## Development & Environment Committee

DE21.57	Proponent Initiated Planning Proposal - Taylors Lane, Cambewarra (Moss Vale Road South URA) - Exhibition Outcomes and Proposed Finalisation	
	Attachment 1 Submissions from Public Authorities.....	2
DE21.59	DS20/1397 – 408 Bunkers Hill Road, Barrengarry – Lot 144 DP 751262	
	Attachment 1 Assessment Report - S4.55 - 408 Bunkers Hill Rd BARRENGARRY - Lot 144 DP 751262 .....	26
	Attachment 2 DRAFT - Determination - 408 Bunkers Hill Road, Barrengarry - Lot 144 DP 751262 (Por 144) .....	52
DE21.60	DA16/1465 - 173 Kinghorne St and 2 & 4 Albatross Rd Nowra - Lot 1, 29 and 30 DP 25114	
	Attachment 1 Previous Report to May Development & Environment Committee.....	69
	Attachment 2 Section 4.15 Planning Assessment Report.....	106

**Re: Planning Proposal PP054 - Rezoning of Riparian Land at Lot 1 DP 949932, Taylors Lane, Cambewarra**

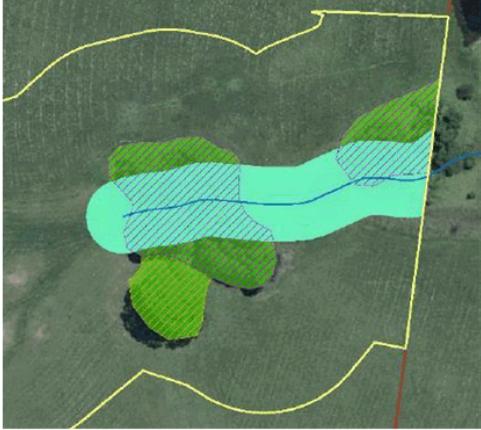
In addition, the PP has measured the corridor width from the centreline of the watercourse which is not correct. The width of the corridor should be measured from the bank of the watercourse or edge of the depression not the centreline. The minimum total corridor width should be 20 metres plus the channel width.

Issue/concern	Response
NRAR concurs with the retention of the existing vegetation in the proposed riparian corridor but does not support the use of the averaging rule to reduce part of the corridor width to 10m.	Noted. It is proposed to remove the use of the averaging rule from the proposal so that the riparian corridor has a uniform width of 20m in between the vegetated areas to be incorporated in the riparian corridor. The amended proposal will correspond with the 'ultimate riparian corridor' suggested in the study by Niche Environment & Heritage (copied below).

<p>Ultimate riparian corridor (blue and green highlighted areas), Niche 2020.</p>
<p>The PP has measured the corridor width from the centreline of the watercourse which is not correct. The width of the corridor should be measured from the bank of the watercourse or edge of the depression not the centreline. The minimum total corridor width should be 20 metres plus the channel width.</p>	<p>Noted. The riparian corridor recommended in the Niche study and on which the PP is based was informed by detailed site analysis including field survey. While it concluded that there is a 1<sup>st</sup> order stream present, it was observed to have no clearly defined bed, banks or channel. Hence the study concluded that the corridor width could be measured from the centreline and that this would be sufficient to maintain the watercourse's conveyance and water quality objectives. The proposed riparian corridor also incorporates the additional vegetated areas which will further assist to maintain bank stability and water quality functions. On this basis it is suggested that the proposed riparian corridor (without the averaging rule) is acceptable in this case and we respectfully ask that NRAR reconsider its position in this regard.</p>

<p>If rezoned, the conceptual subdivision and road layout should be reconsidered so as to provide for physical separation of the riparian area from the residential zone as opposed to having lots backing onto the riparian corridor as currently illustrated.</p>	<p>Noted. Further consideration will be given to the layout as part of the assessment of any development application by Council, if the land is rezoned.</p>
<p>The corridor should not be reduced in width where proposed</p>	<p>Noted. Further consideration will be given to the layout as part of the assessment of</p>

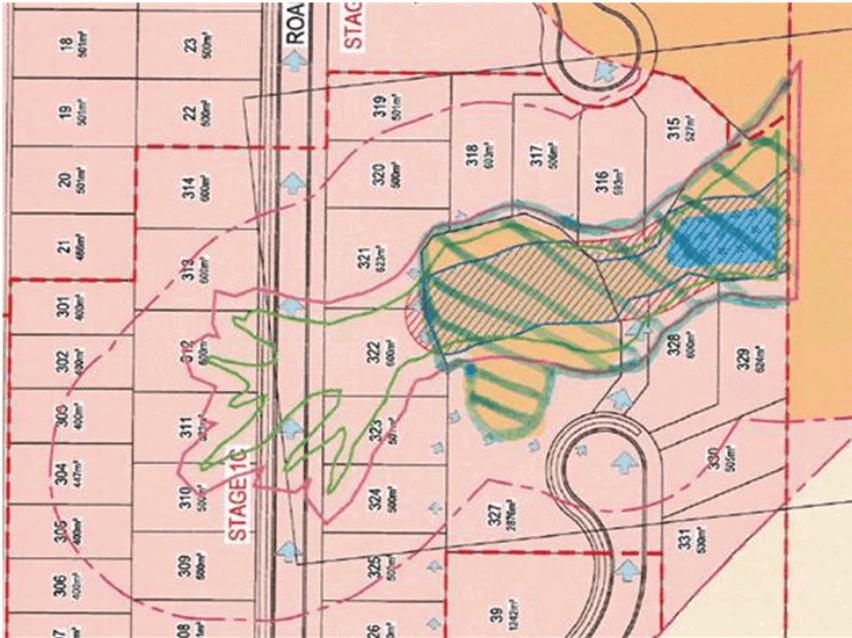
Only exception is in relation to the measuring of the riparian corridor from the centre of the watercourse rather than the bank. I was referring to Figure 6 and Table 3 of the Niche report which defines a bank as illustrated below.

Thanks again for your additional comments. Can you advise if NRAR would be supportive of a revised proposal based on the draft mark-up attached (and shown below)?

It shows a revised riparian corridor (proposed E2 zone) in green hatching, with the western extent of the corridor located at the trees proposed to be retained, and incorporating a 5m buffer measured from the 'bank' (blue line) shown in Figure 6 of the Niche study.

Figure 4: Recommended riparian extent (Niche Environment & Heritage, 2020)

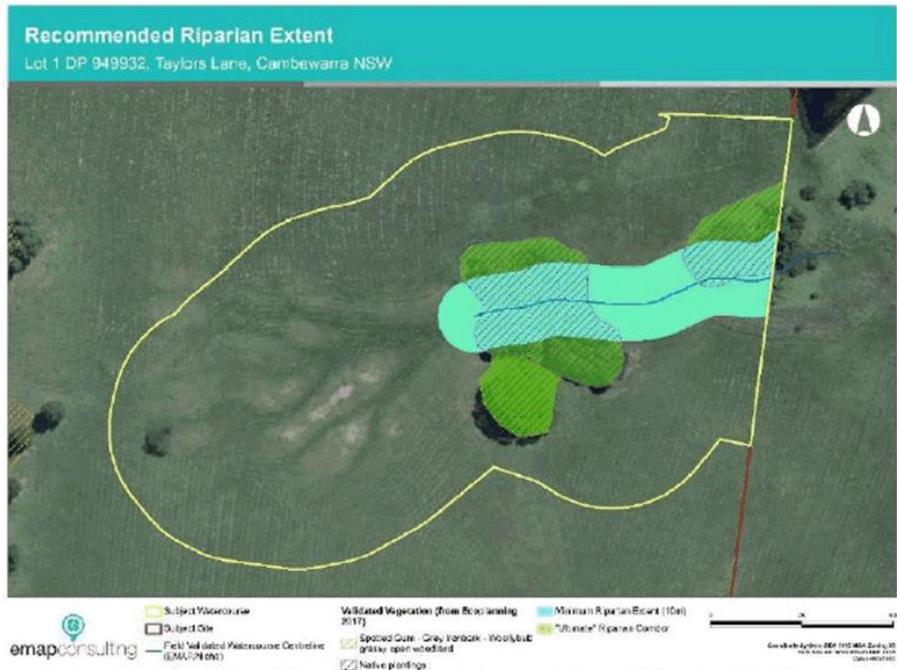
- Retaining land within 10m of the watercourse centreline as a minimum riparian corridor/zone will maintain the conveyance and water quality functions of the watercourse.
- Retaining the native vegetation in the vicinity of the watercourse within a wider riparian corridor will enhance the ecological function of the watercourse and provide the opportunity to improve vegetation condition and habitat quality.

- Apply the principles of the “averaging rule” described in NRAR Guidelines for riparian corridors to reduce the width of the minimum recommended riparian corridor in several unvegetated places.

Figure 15 - applicant's submitted concept plan, demonstrating that access via Kinghorne Street is capable of being achieved.

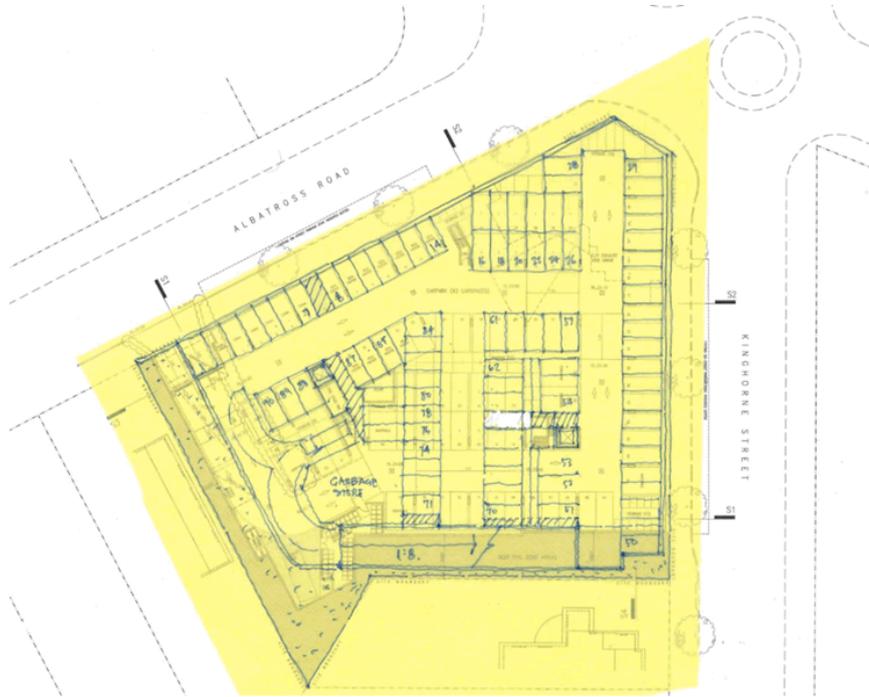
The applicant has submitted concept plans (D18/355817) (refer to **Figure 15**) to demonstrate that practicable and safe, vehicular access to the land can be provided by a road (Kinghorne Street) other than the classified road.

The desired outcome is for access to the land to be via the unclassified local road – Kinghorne Street, which will ensure that the development does not compromise the effective and ongoing operation and function of the classified road (Albatross Road).

Figure 16 – Extract of the proposed basement plan indicating the location security door and intercom to gain access to the basement car park.

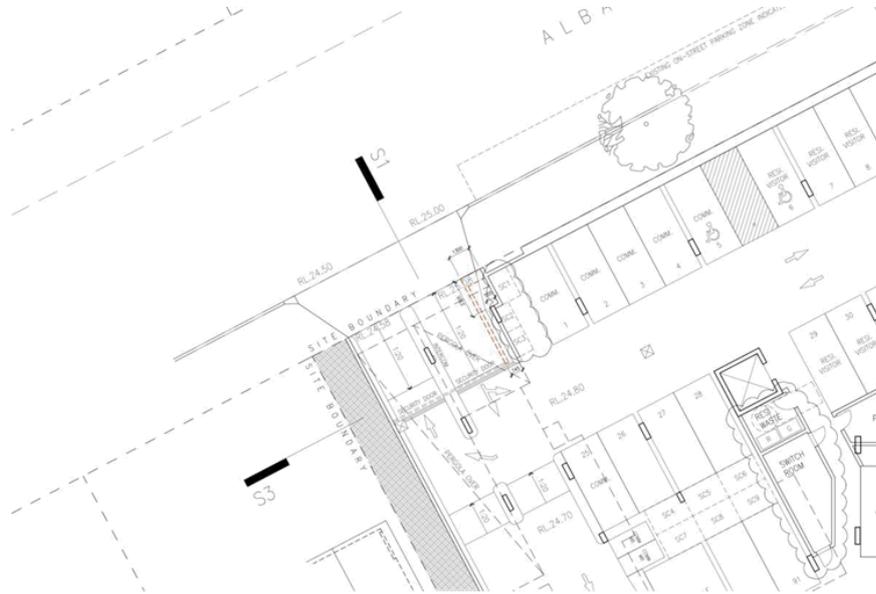
- The proposal is likely to set an undesirable precedent granted the nature of the variation.
- The site is outside of the contribution area for parking and therefore developer contributions cannot be levied for the shortfall in on-site spaces.

- The development is located in a regional area. Residents are heavily reliant on private motor vehicles for transport as opposed to good, accessible, and frequent public transport. Therefore, adequate parking should be provided.

Figure 18 - Height plane instructions relating to the 14.0m (N2) maximum building height – south-eastern view from Kinghorne Street.

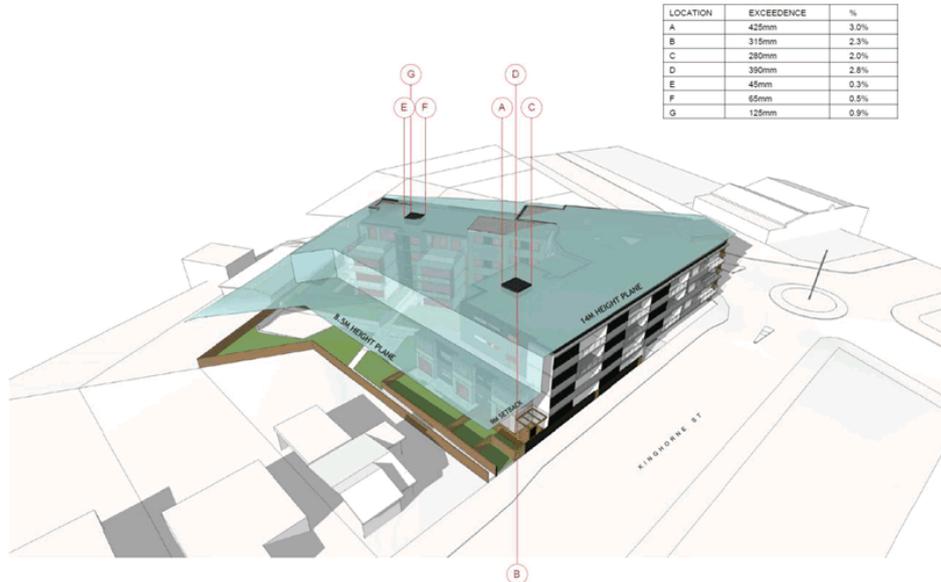
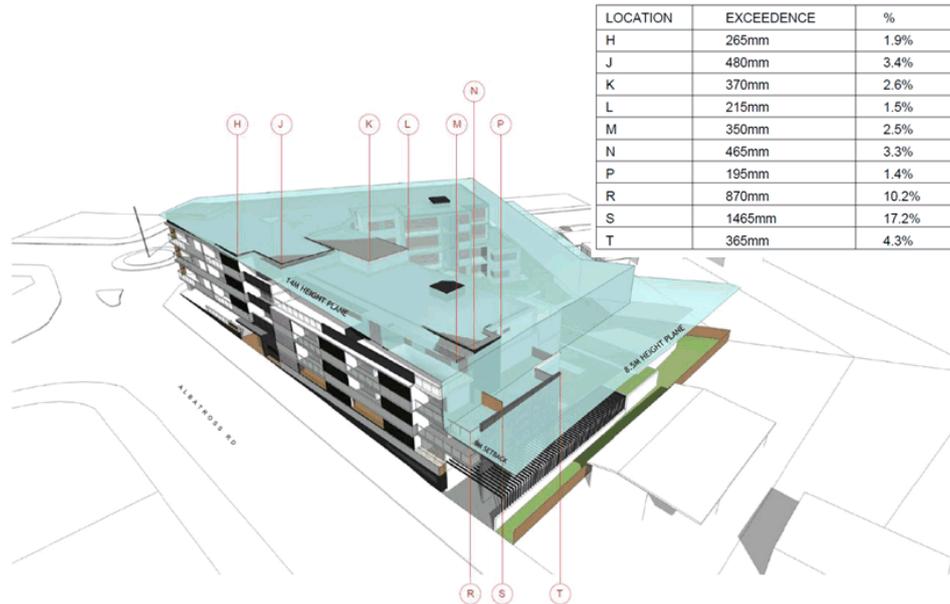
- 14m height limit by 480mm or 3.4%;
- 8.5m height limit 1.465m or 17.2%; and
- The percentage exceedance of the maximum building height ranges from 1.4% to 17.2% with the average height limit exceedance being 4.83%.

The submitted height plane diagrams prepared by Kannfinch Architects illustrate that the height limit breach and indicate the percentage breach at each point (Refer to **Figure 18 and 19**).

Figure 16 - Height plane instructions relating to the 14.0m (N2) maximum building height - south-eastern view from Kinghorne Street.

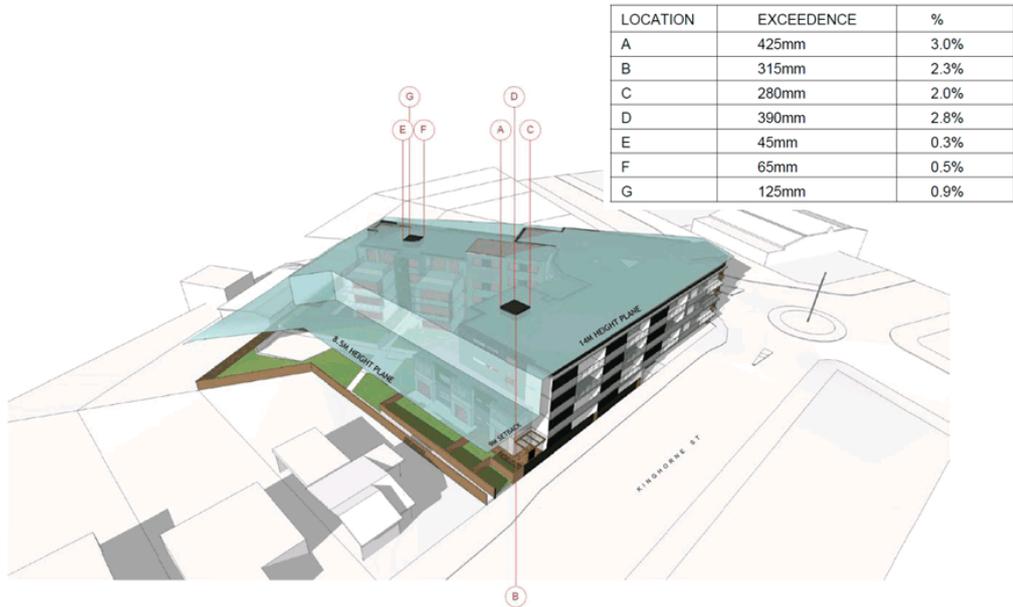
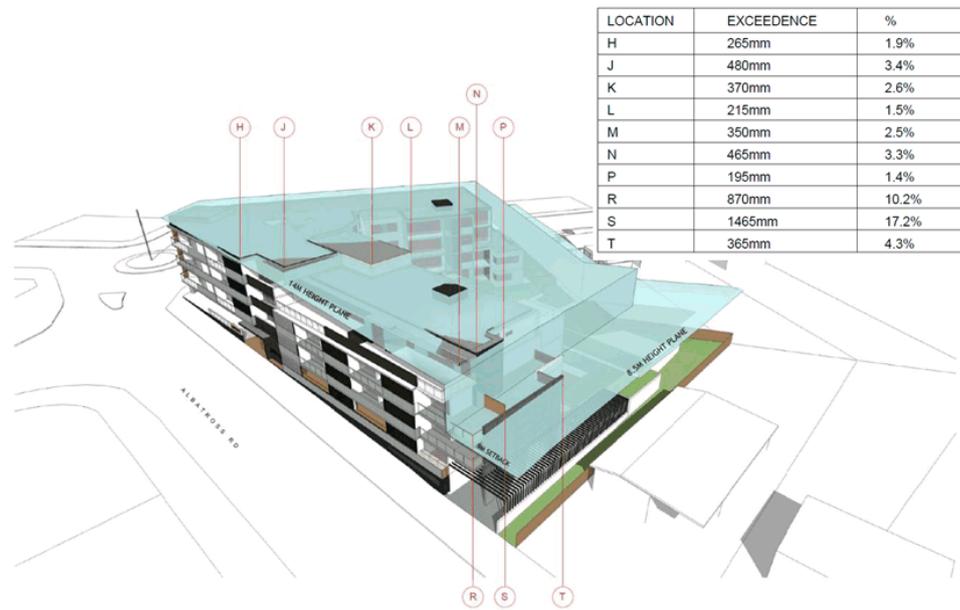
The submitted height plane diagrams prepared by Kannfinch Architects illustrate that the height limit breach and indicate the percentage breach at each point.
